Our Ref: 1-474-TN-005  
12 February 2026

## AIRPETS VEHICLE ENTRANCE, HEATHROW AIRPORT, LONDON (TW19 6BW) RESPONSE TO HILLINGDON COUNCIL HIGHWAY COMMENTS

This Note has been prepared in response to Highway Comments received from Hillingdon Council on 04-02-26 and 05-02-26 from Wai Hing Tse.

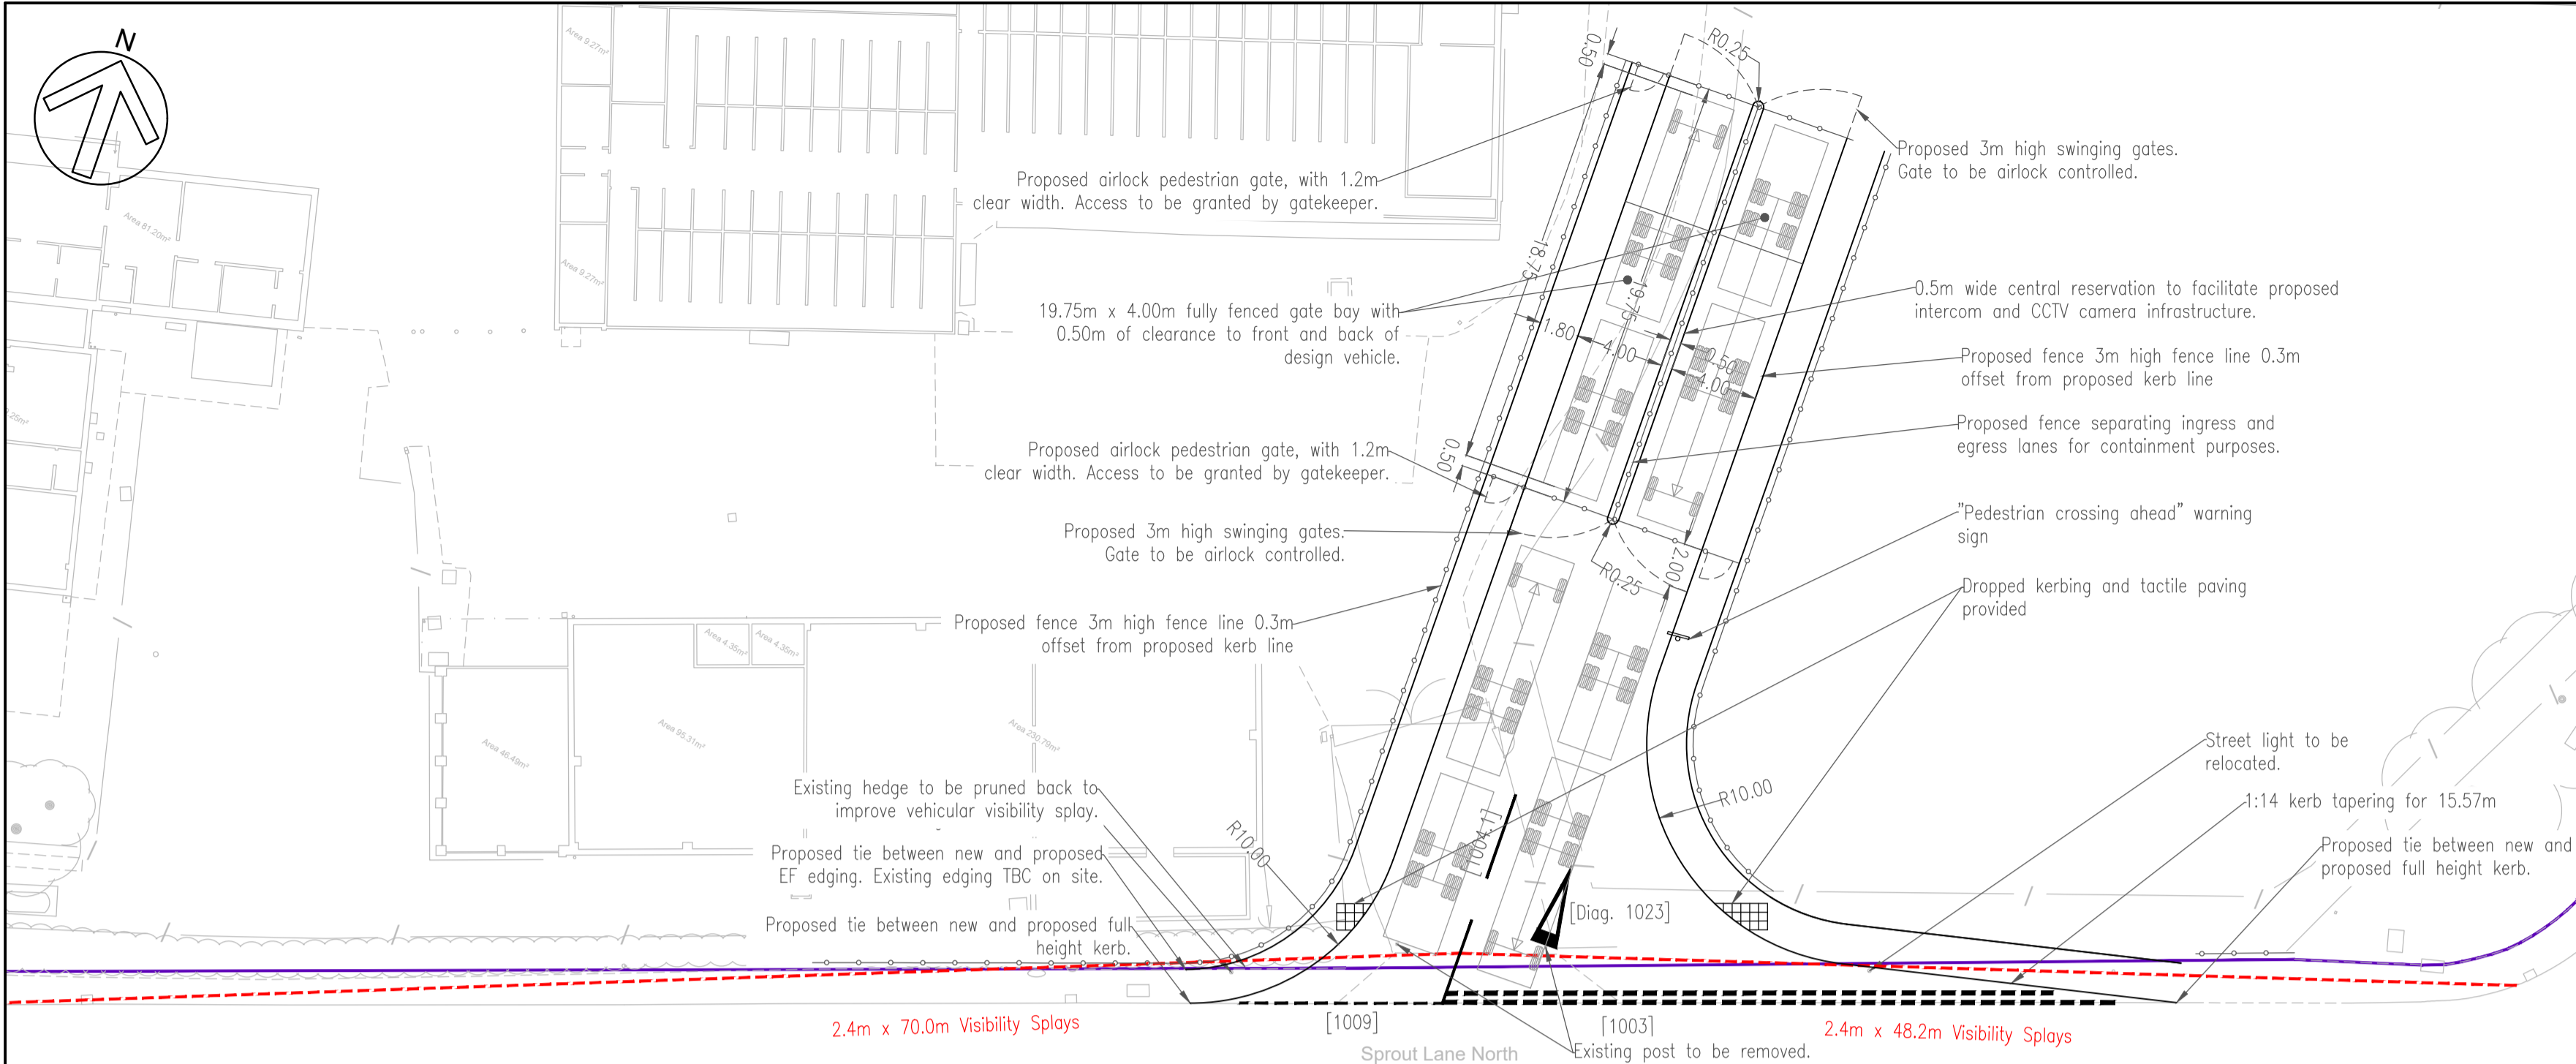
*“Scaled drawings showing the existing and proposed access geometry, levels, widths, visibility splays and gate positions.”*

- See Appendix A (please note this information was already fully shown within Civilistix technical note TN2/1-474 dated 09 October 2025)

DRAWING TITLE: **Proposed Access Engineering Layout Option 1**

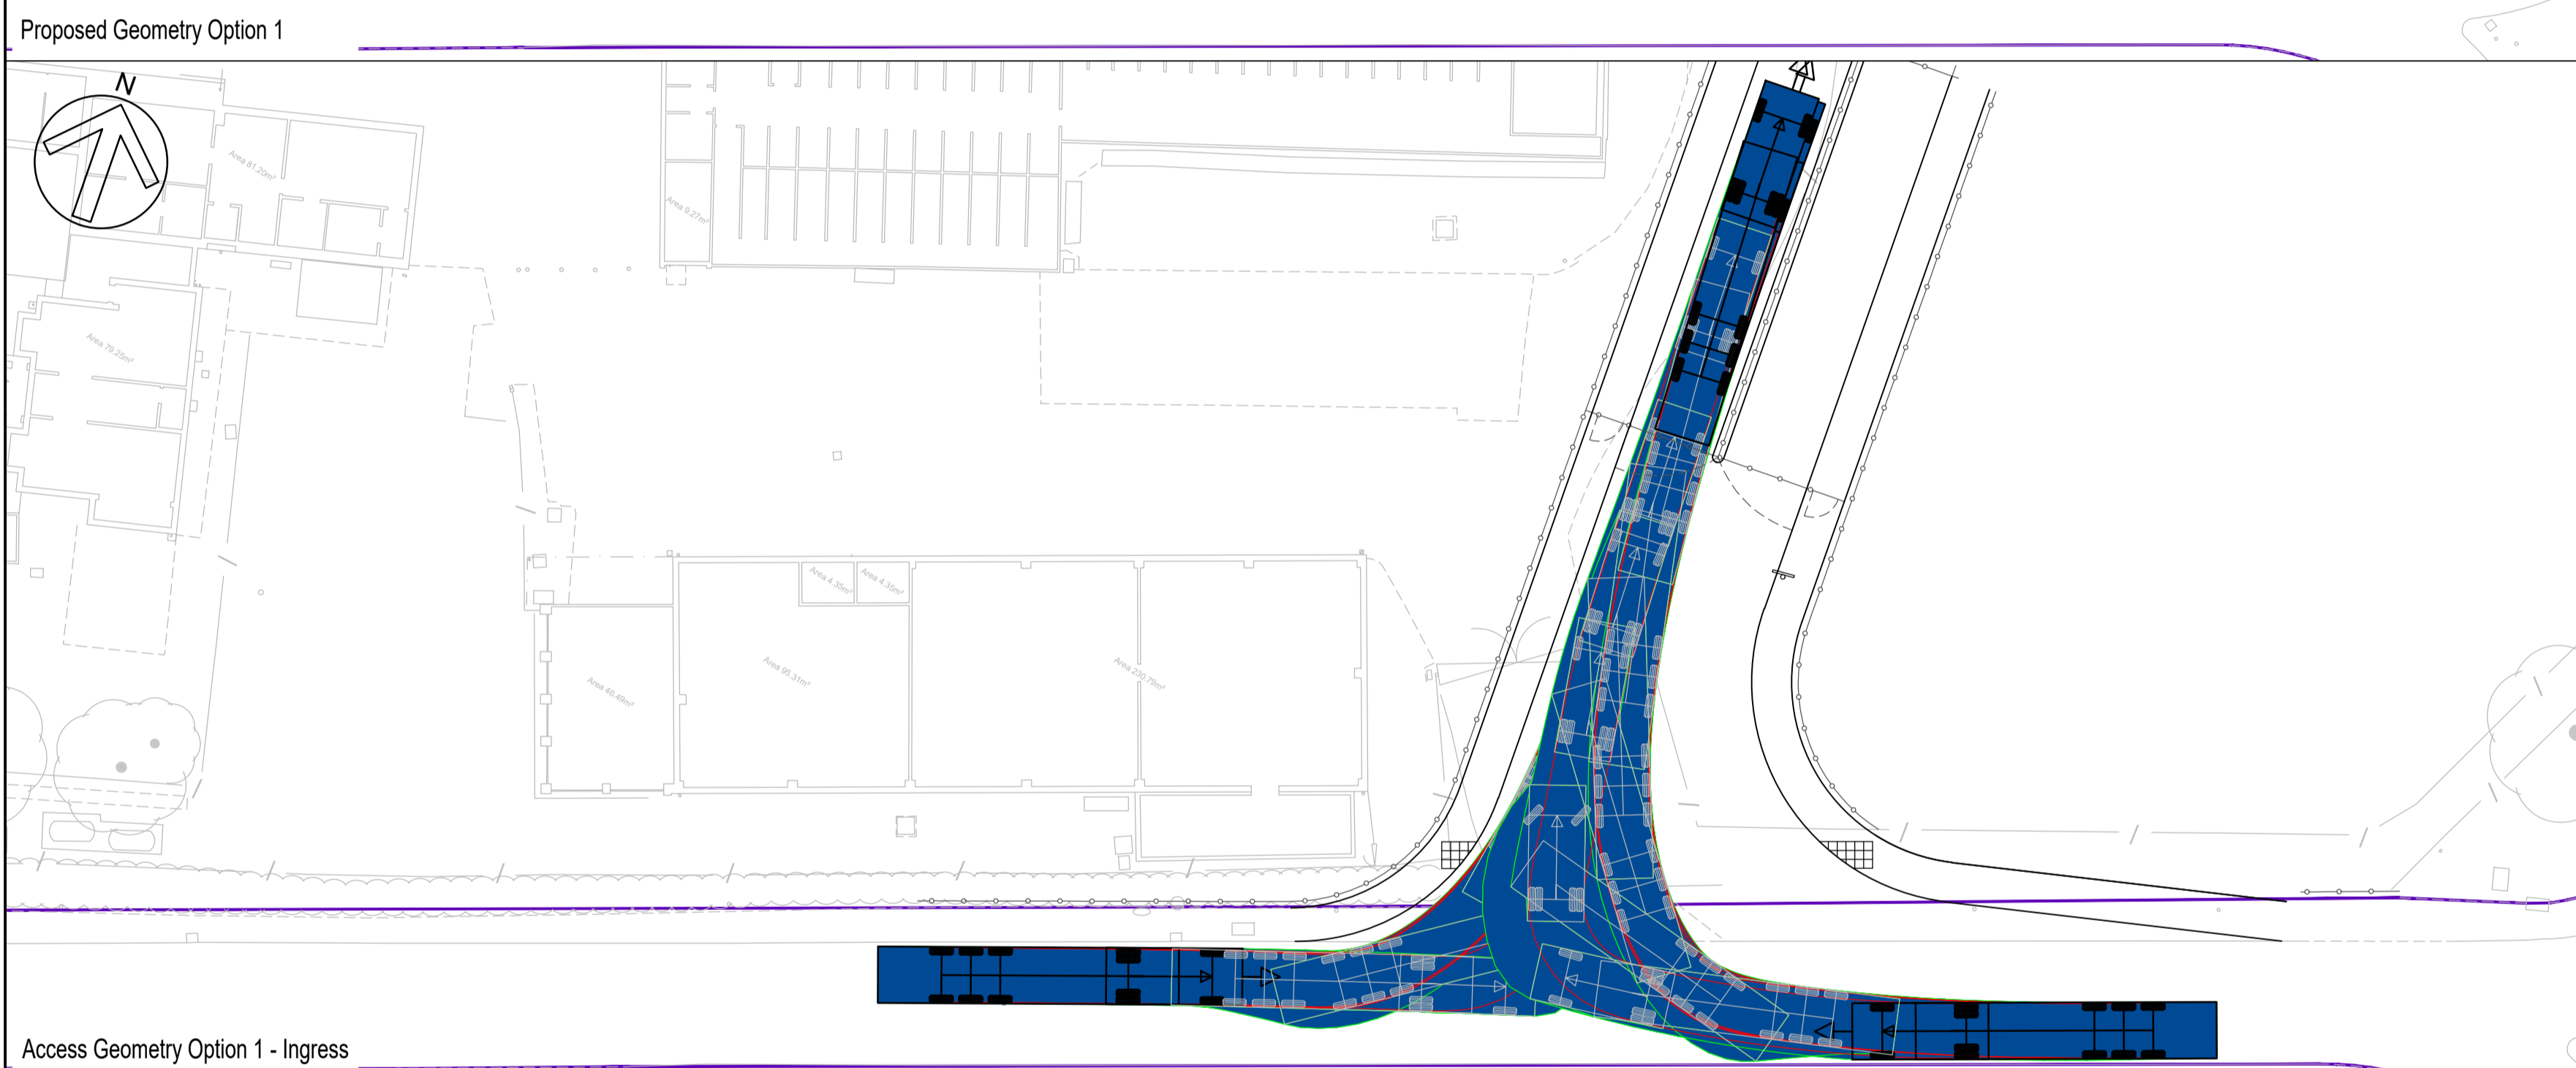
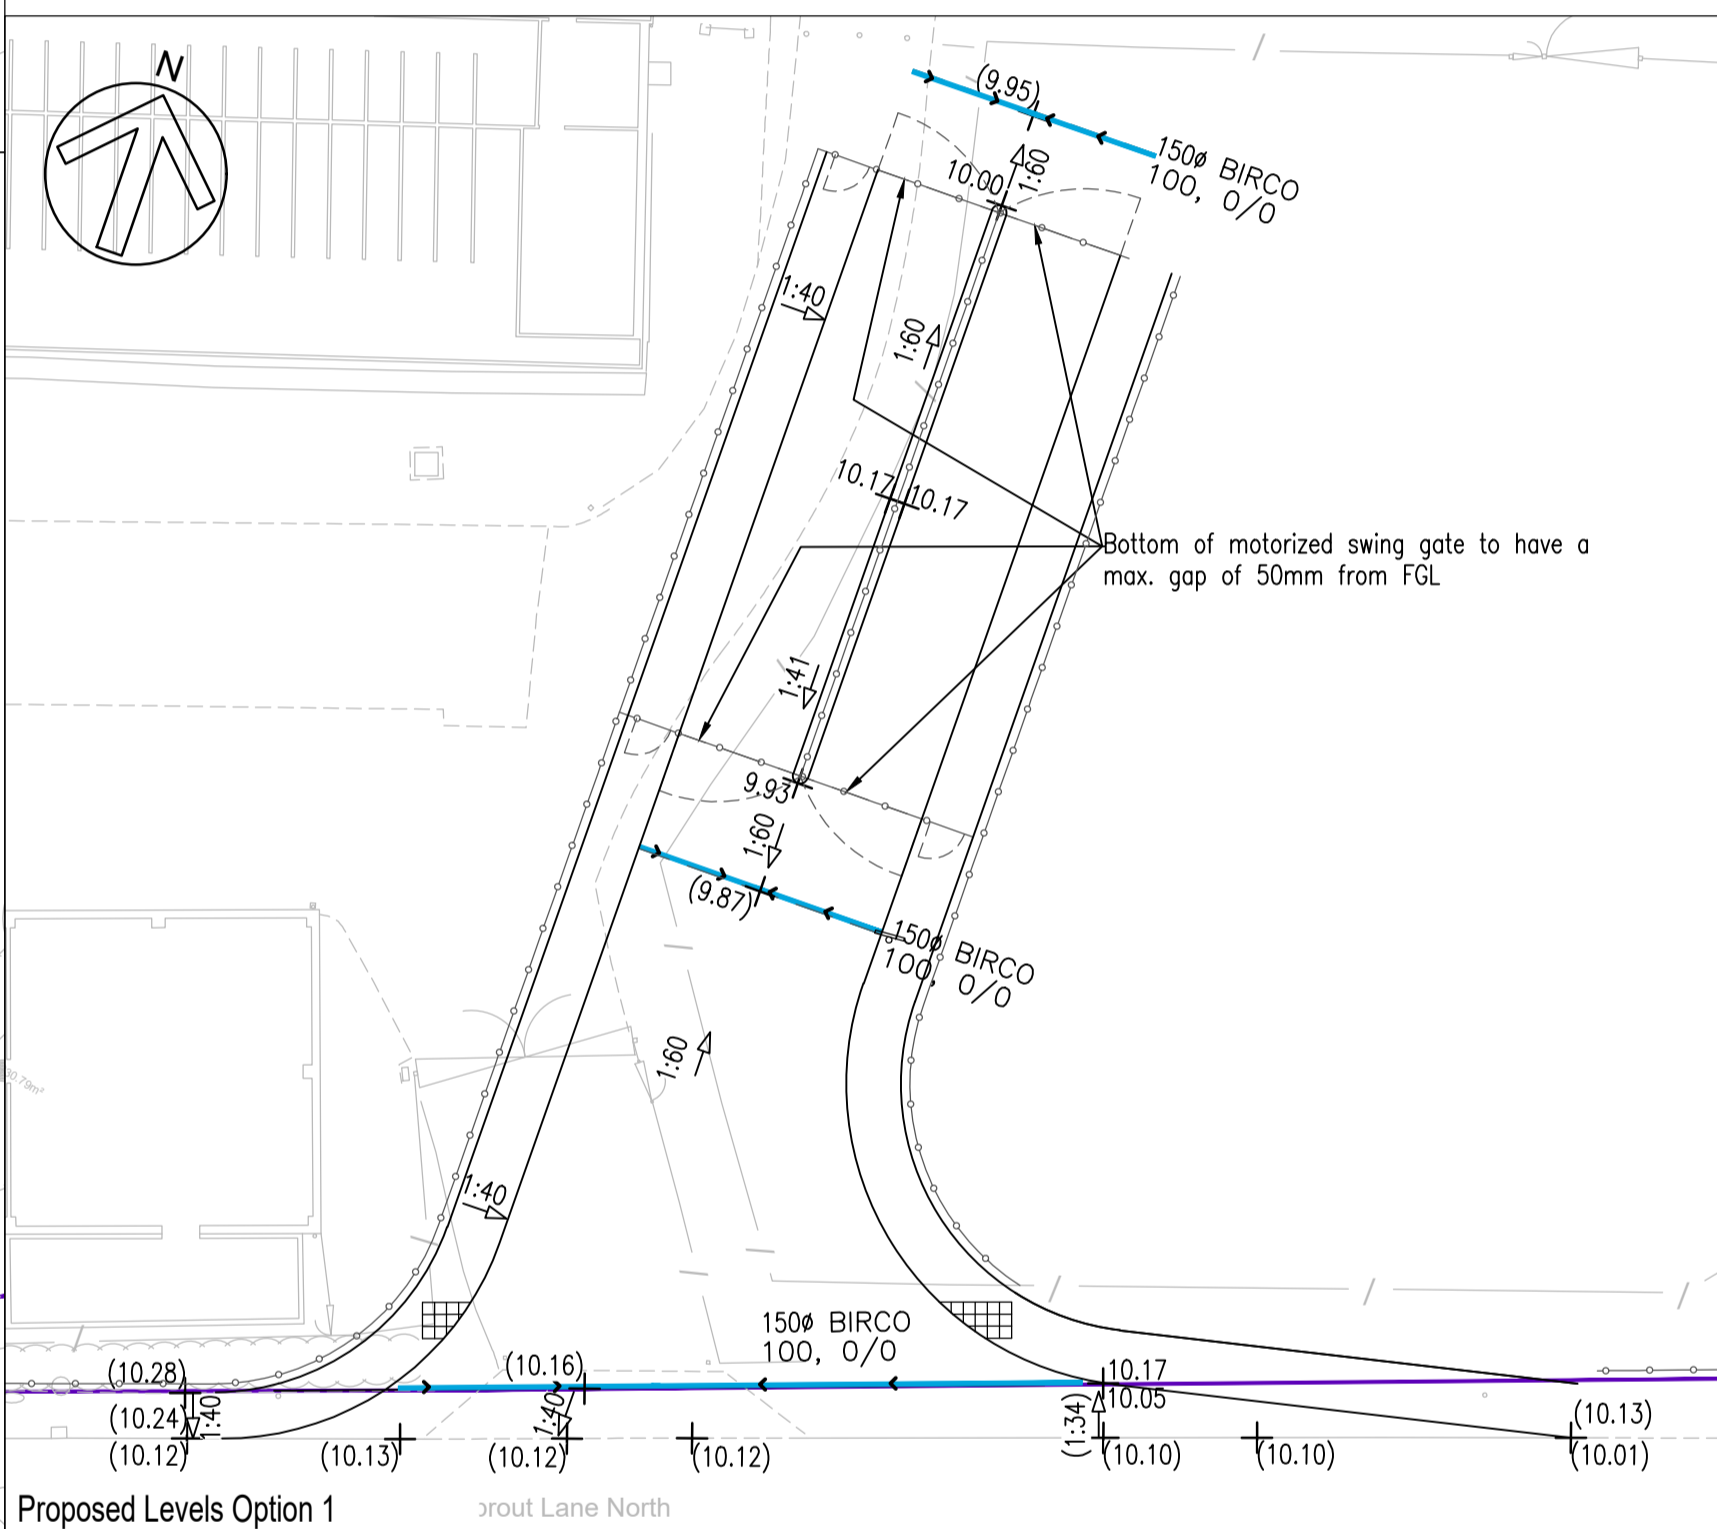
*“Consideration of pedestrian safety implications of the wider access, including any mitigation measures”*

*“The plans also show visibility splays; however, no detailed information has been provided regarding the extent, length, or justification of these splays, nor any demonstration that they comply with the relevant guidance (MfS/DMRB). For commercial/HGV-serving accesses, visibility splays are normally assessed from an X-distance of 4.5 m, in accordance with established standards for commercial and HGV-serving accesses and further information is required to confirm whether the proposed arrangement provides adequate intervisibility”.*

- “Pedestrian Crossing Ahead” warning signage has now been added to the approach to the junction to warn HGV drivers of the possibility of pedestrians crossing.
- Vehicles egressing Airpets would clearly be able to see pedestrians approaching the junction and could give-way accordingly whilst they navigate the junction
- Tactile paving and dropped kerbing are now proposed to the bell-mouth of the junction
- Spout Lane North, currently provides a weak pedestrian desire line with minimal pedestrian facilities / amenities within walking distance along Stanwell Moor Road

- We do not believe DMRB is the most appropriate design guide to design visibility to given the road is 30mph design speed (and therefore fully in the realm of MfS design guidance) and given the cab arrangement of HGV tractor units brings drivers closer to the give-way line than other vehicle types.
- The visibility splays shown are fully in line with MfS guidance.
- The proposed junction improves visibility from the existing scenario as demonstrated within Civilistix technical note TN2/1-474 dated 09 October 2025
